OVERLAND FLOW REPORT STAGE 1

PROPOSED DEVELOPMENT: MAMRE WEST PRECINCT ORCHARD HILLS NSW

Project Title	Mamre Road, Erskine Park
Document Title	Overland Flow Report – Stage 1
Project No.	12042.00
Description	Overland flow assessment for new industrial development.
Client Contact	Mr Tim Ireson, Hansen Yuncken

8. PEER REVIEW

Figure 6.1. Model Extent and Model Boundary Locations

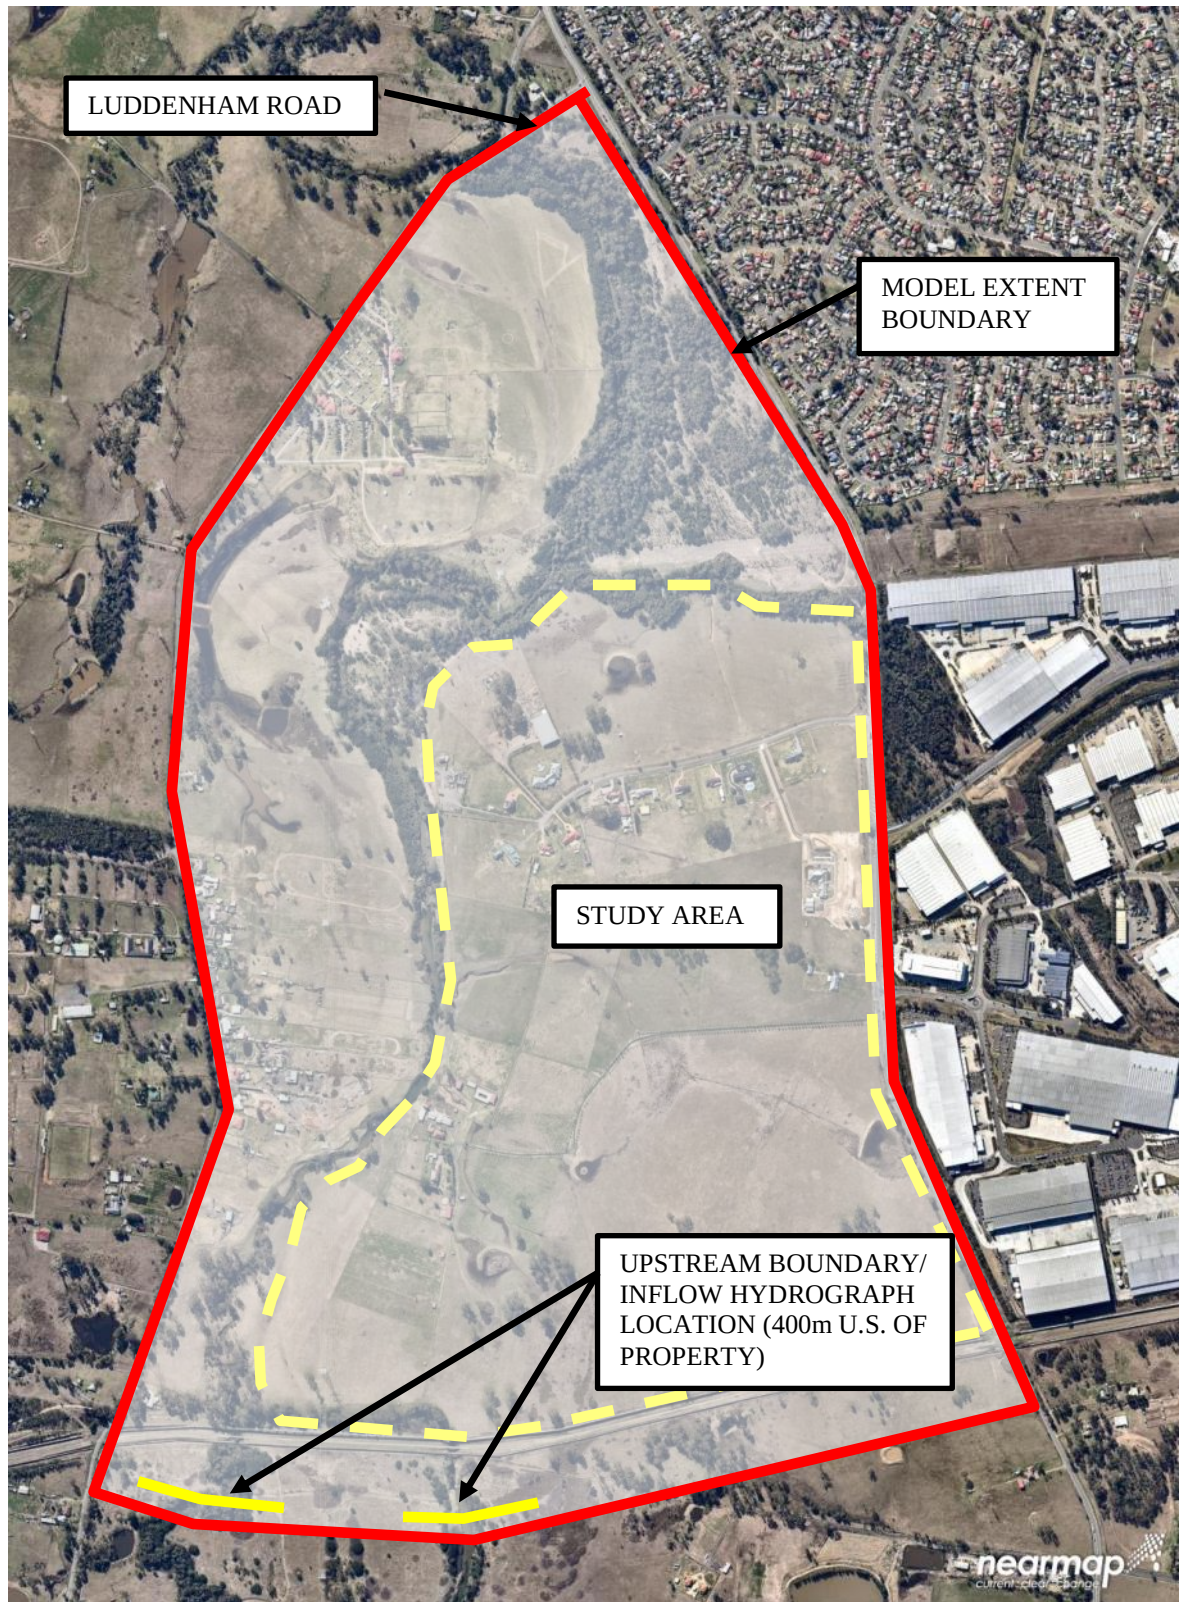
Item B1.a) The downstream boundary levels are inappropriate and require review and update. It is recommended that peak flood levels from the RMA-2 flood model be adopted to ensure consistency. These peak flood levels are provided within Table 1.

Item B1.b) The upstream boundary should be located a sufficient distance upstream to cover the extent of predicted impacts from the proposed development. It is unclear if sensitivity analysis has been undertaken to ensure the current set-up is satisfactory.

Modeling has been updated to include the recommended downstream flow boundaries. Confirmation of the downstream boundary levels used has been included in **Section 6.2** of the report.

A sensitivity analysis has been undertaken which confirms the upstream boundary, located 400m from the property boundary, is sufficiently located far enough from the property to enable appropriate scenario testing relating to the proposed development.

Please refer to **Section 6.2** and **Appendix E** of the report.

TUFLOW AND RMA-2 MODEL COMPARISON

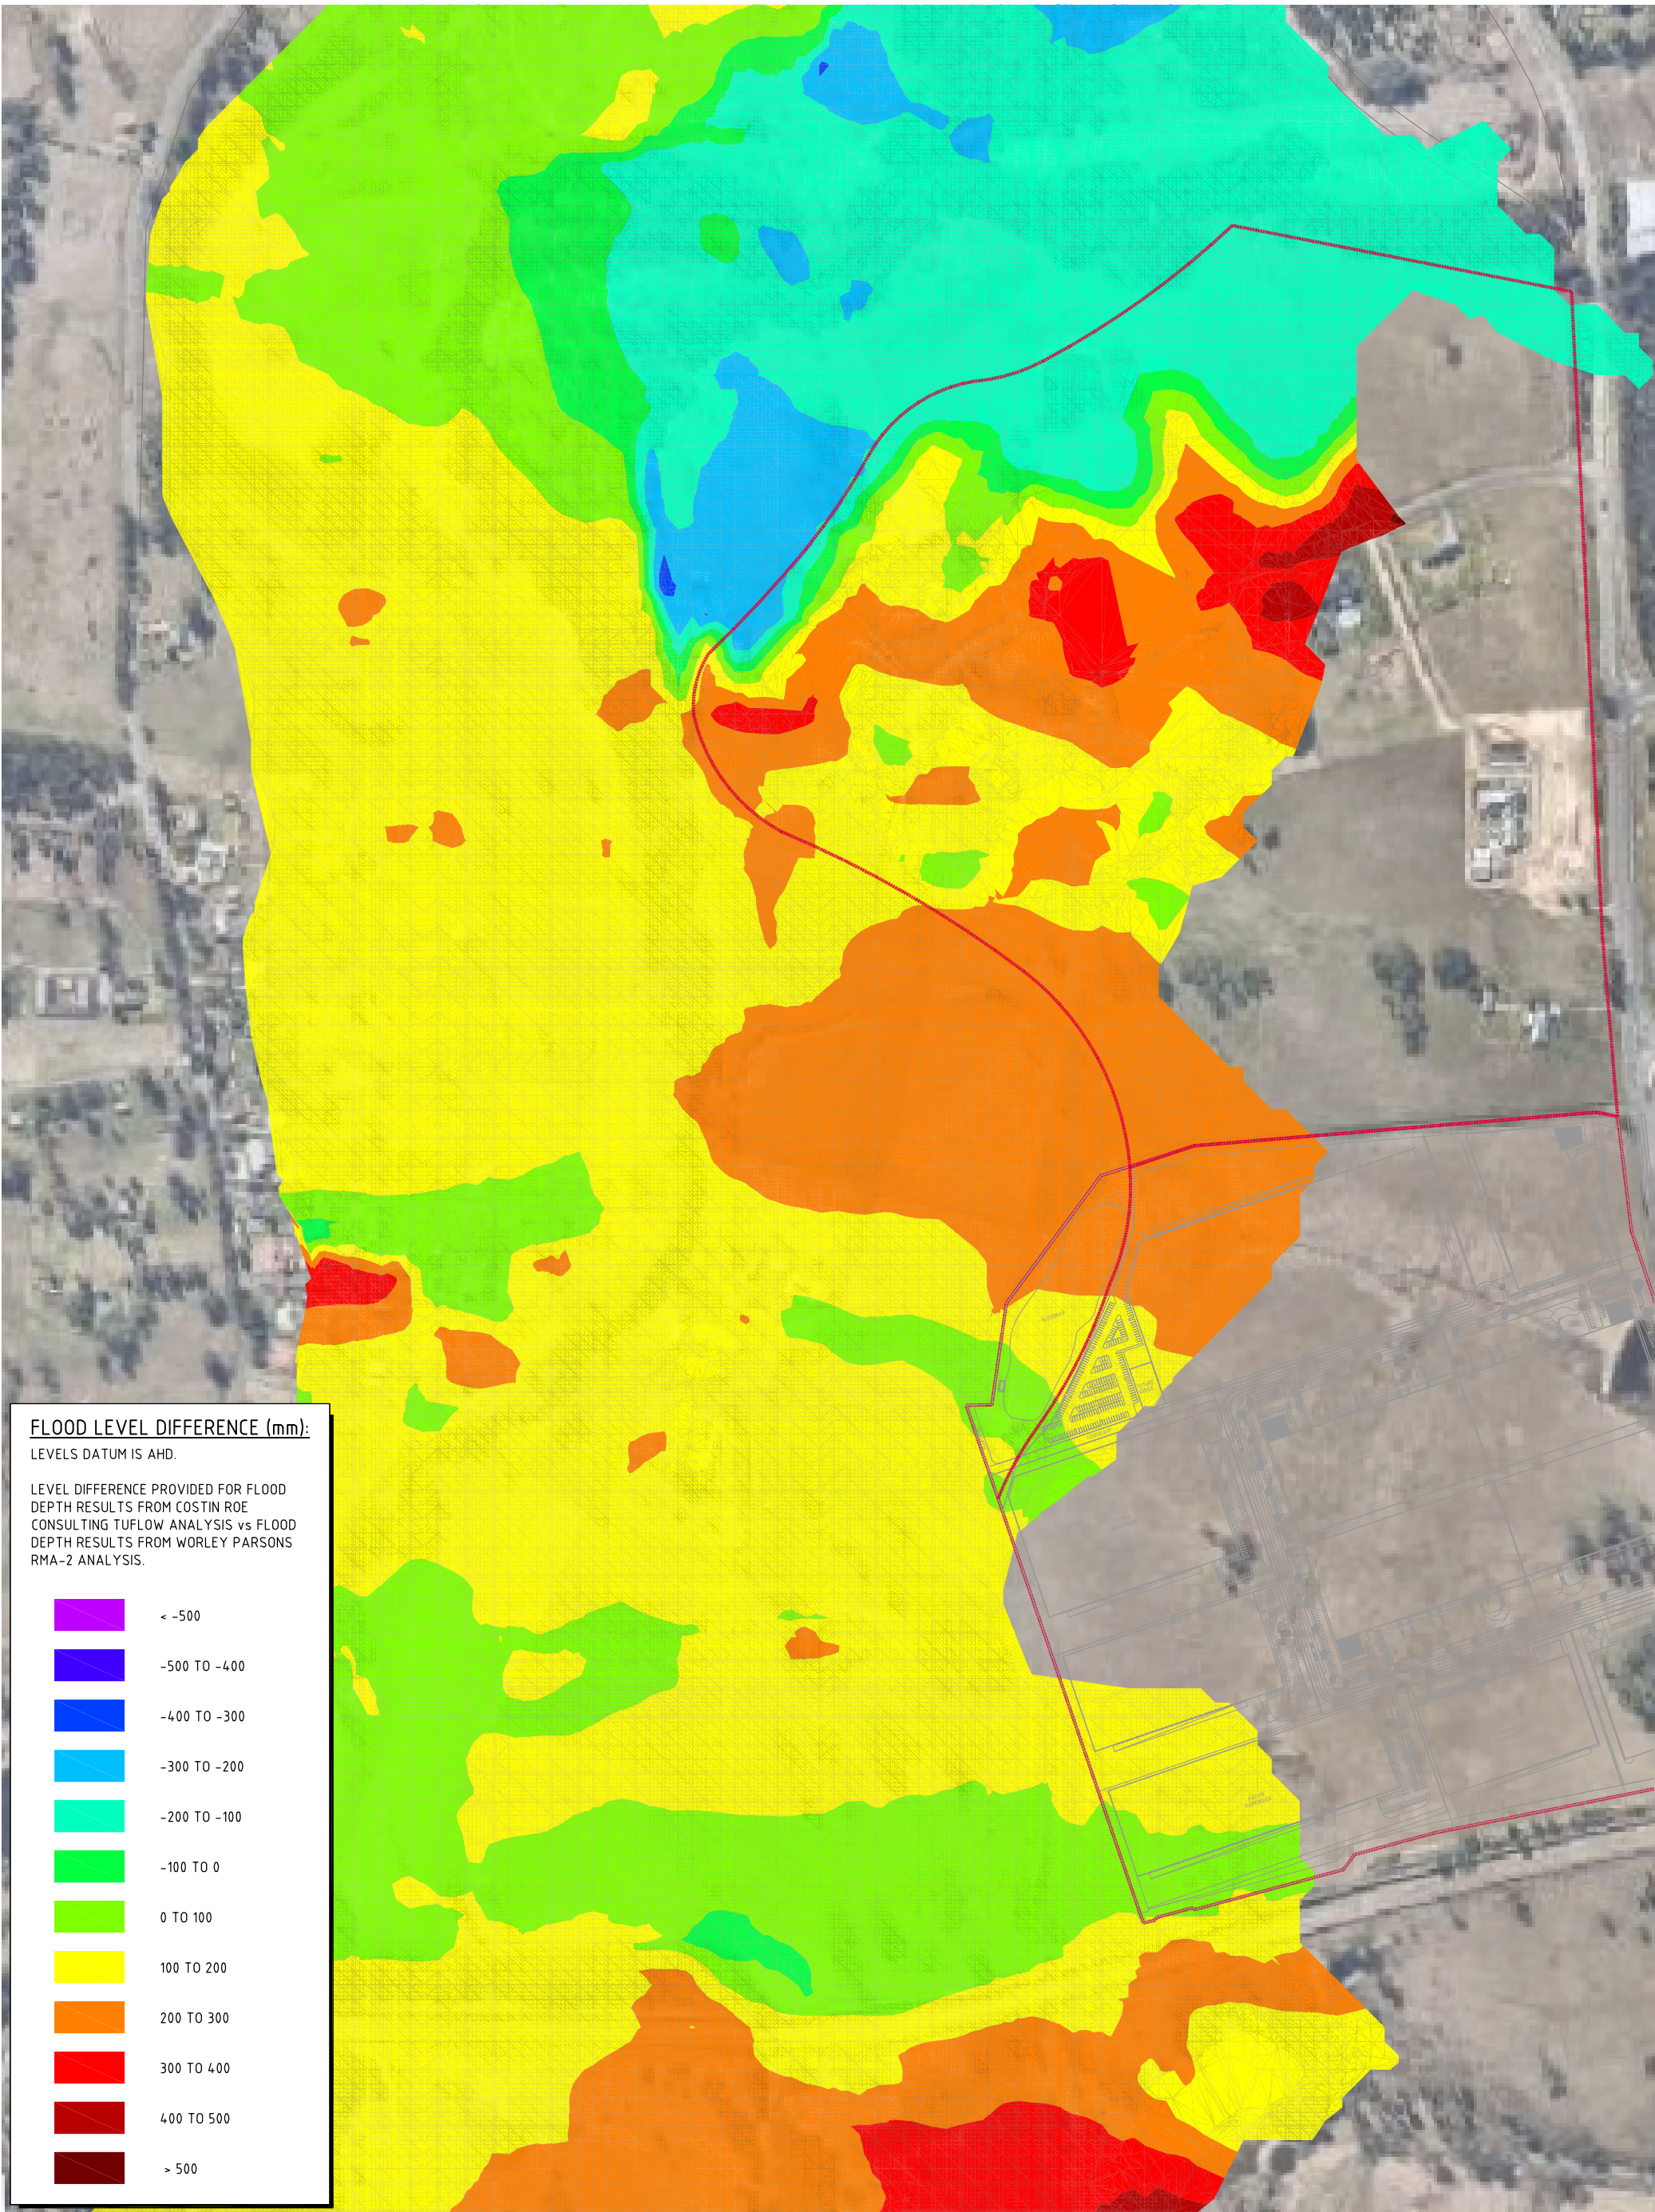
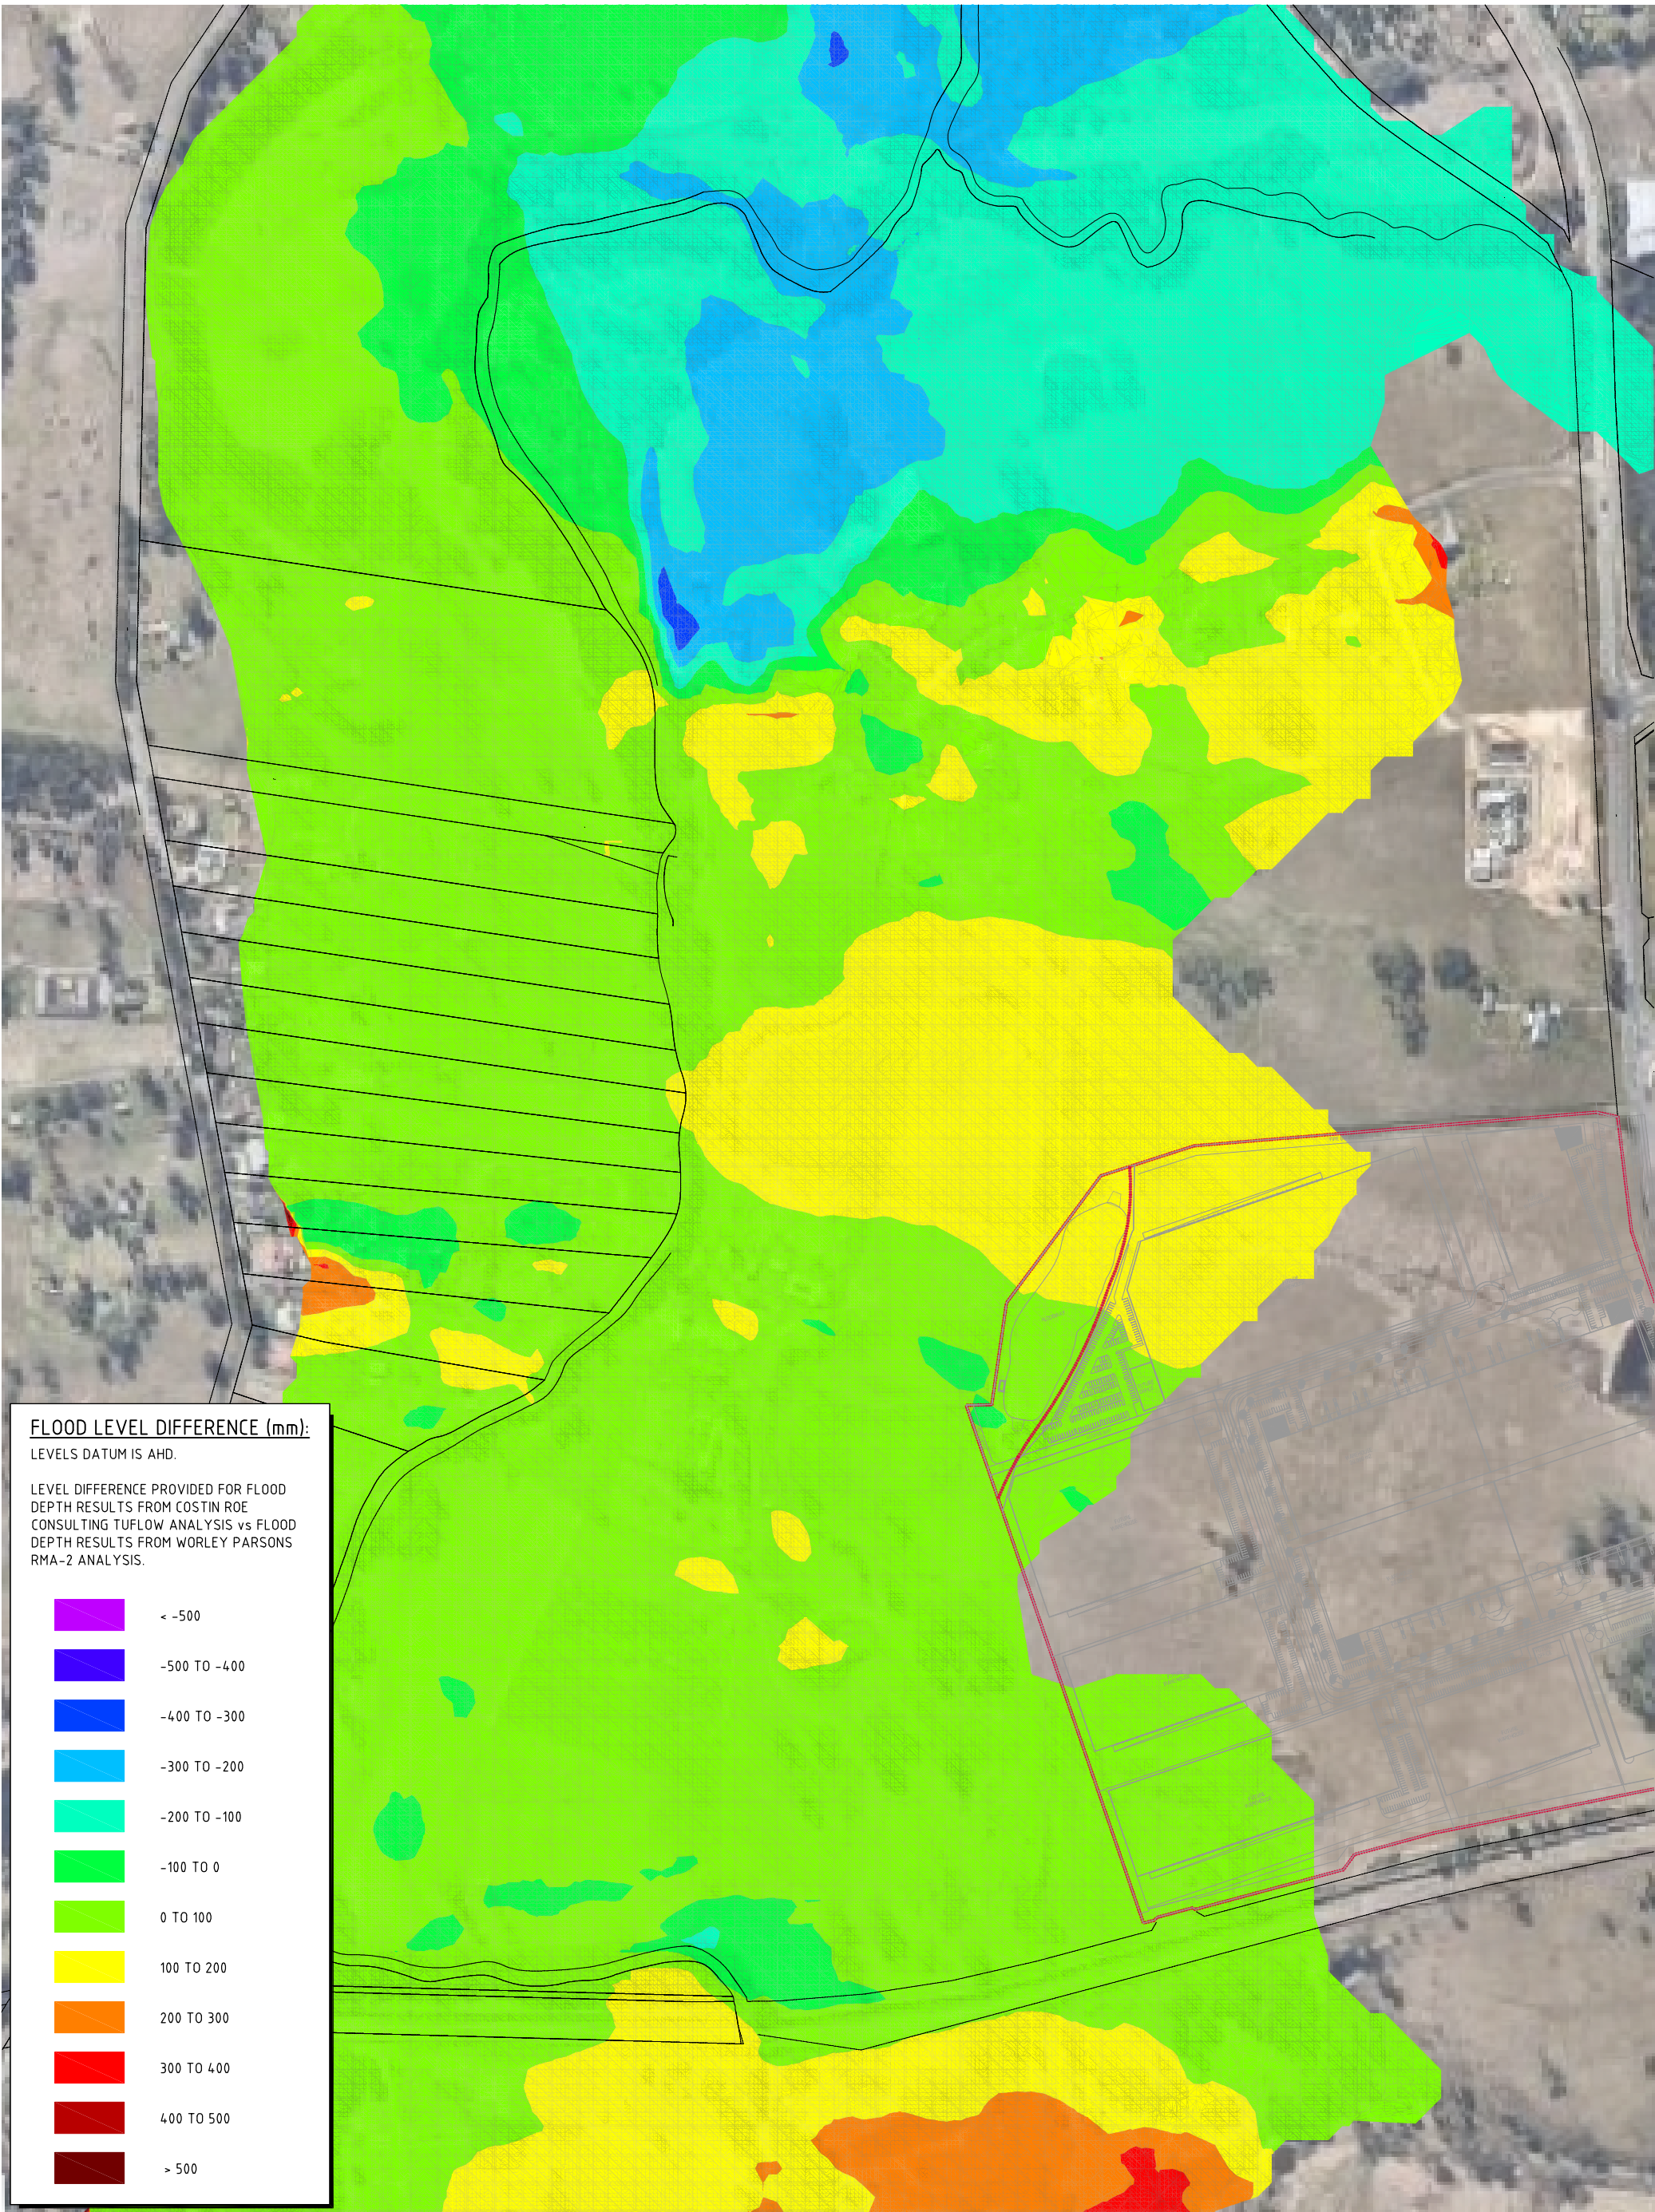
- Item B3 The TUFLOW and RMA-2 results documented in the South Creek Flood Study (Final, 2015) should be compared based on peak flood levels and not depths. Any differences should be presented and discussed similar to Section 3.2.1 and Figure 3 to Figure 6.*

Model comparison results have been adjusted to show differences in flood surface levels rather than flood depths. Please refer to **Appendix B** of the report.
